Subject: Responses to NRC Staff Questions  
R. E. Ginna Nuclear Power Plant  
Docket No. 50-244

Attached are responses to questions from the NRC staff  
concerning our Application for Amendment to Operating License  
dated April 2, 1984.

# AUXILIARY BUILDING SFP AREA

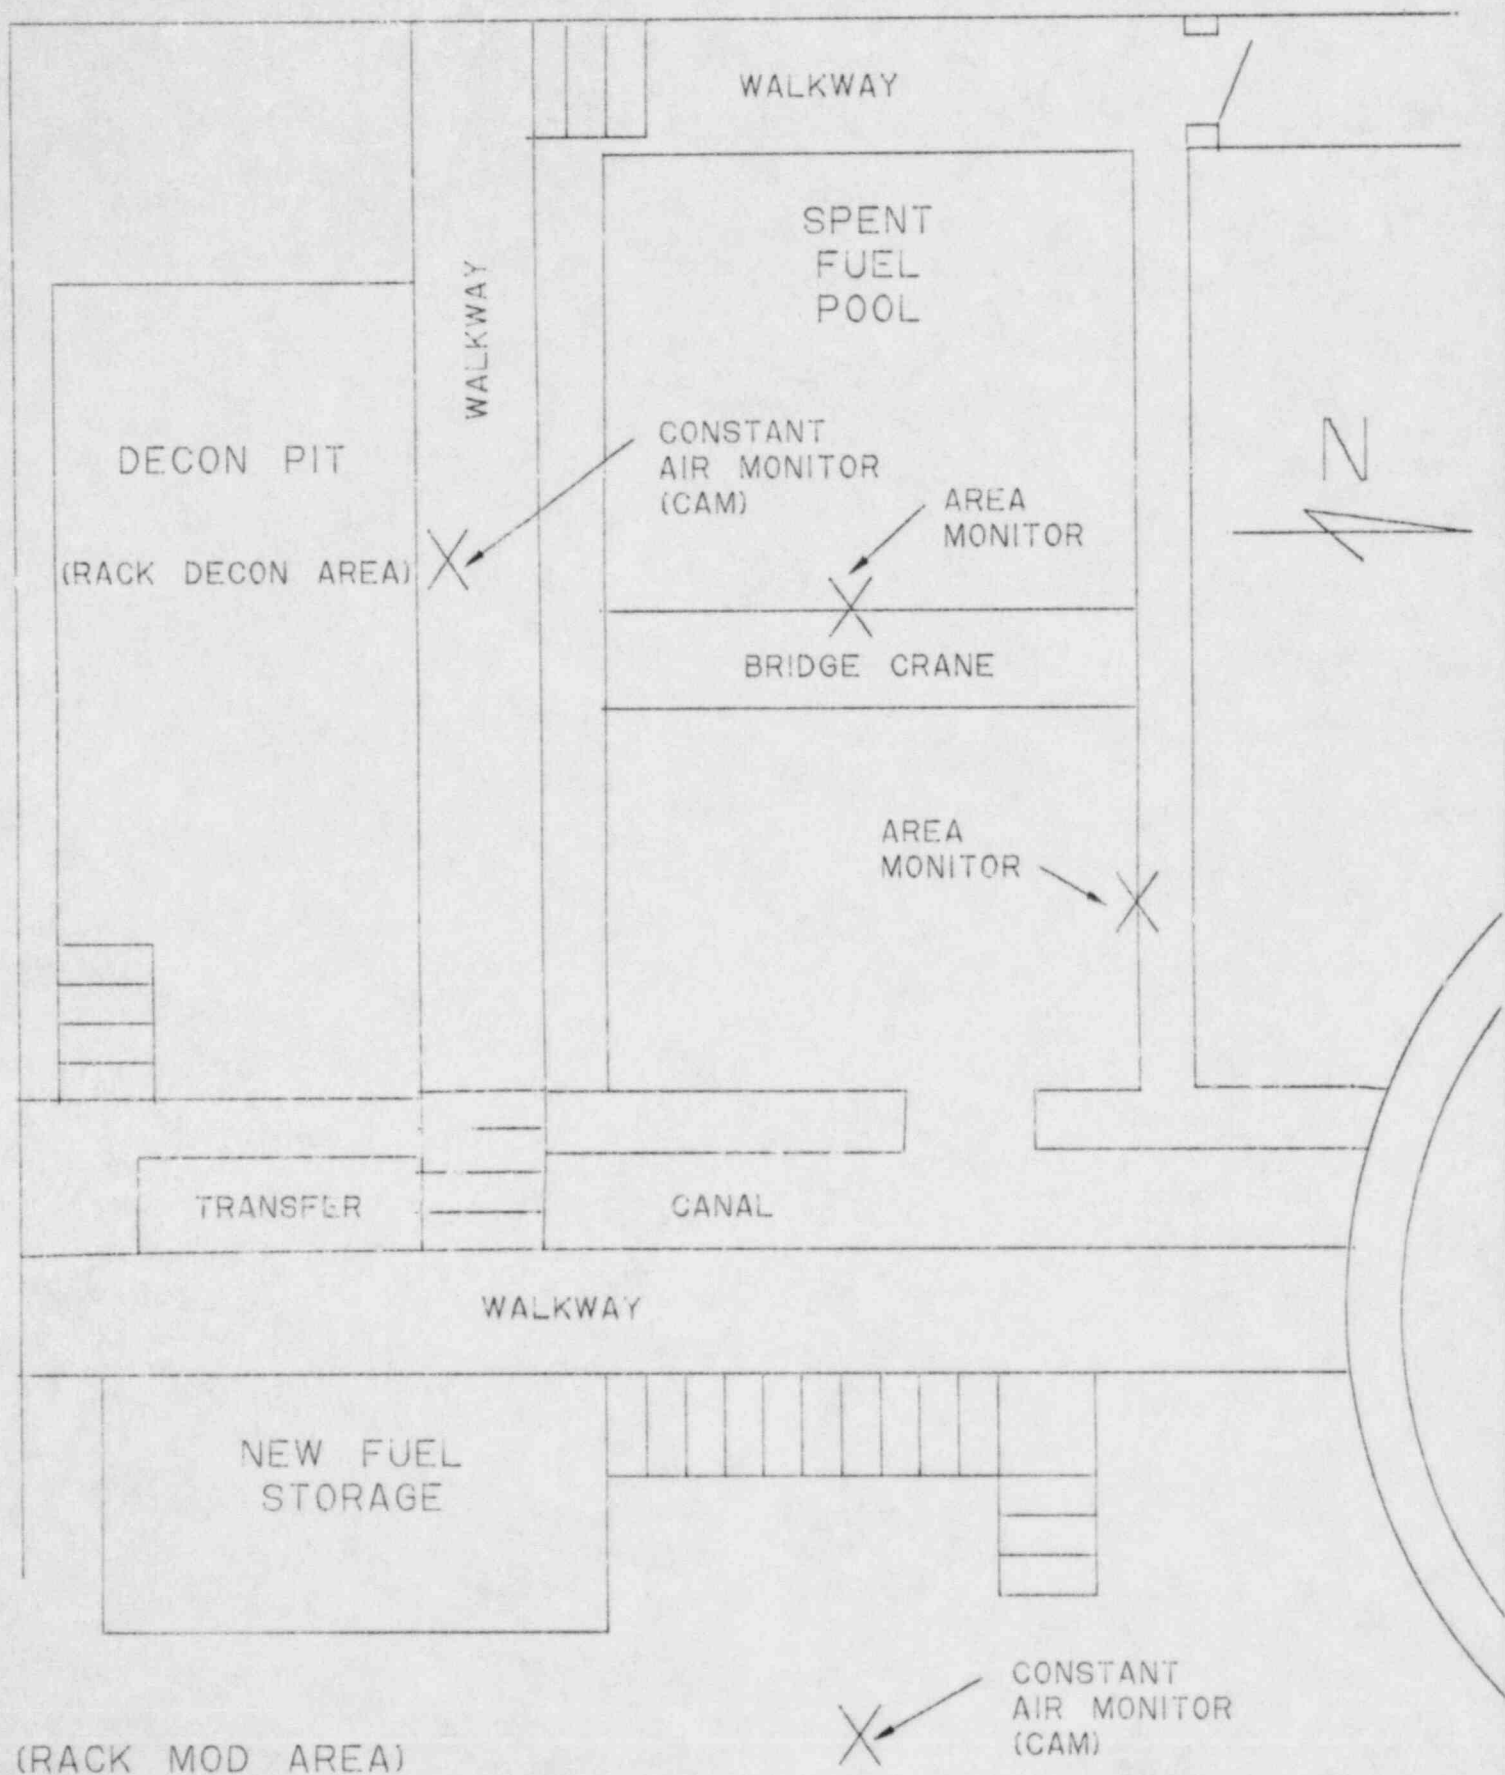
Question 6. Section C.2.9 of Regulatory Guide 8.8 states that the use of radiation monitoring systems to measure dose rate and airborne radioactivity levels in selected plant areas can reduce the exposure of station personnel in these areas. Describe your plans for providing area radiation and airborne radioactivity monitoring in the spent fuel pool area during the spent fuel pool storage rack modification. Provide a layout drawing of the spent fuel pool area showing the location of all area monitors and air samplers.

Response: Area radiation and airborne radioactivity monitoring will be performed in the spent fuel pool area during the rack modification. Radiation area monitors will be provided on the fuel handling crane bridge and on the north wall of the SFP area. In addition, items removed from the SFP will be surveyed by portable survey instruments. The racks will be removed from the pool and placed in the Decon Pit where they will be decontaminated in an enclosed area. The enclosure will be exhausted by an air mover with HEPA filters. A constant air monitor (CAM) will be used to monitor for airborne radioactivity outside the enclosure. Breathing zone samplers will be worn by personnel inside the enclosure. After decontamination, the rack will be moved to another enclosure on the auxiliary building operating floor. Air monitoring will be provided in a similar fashion as described for the decon pit area. Grab samples will be taken for airborne radioactivity as required by conditions or to provide additional information.
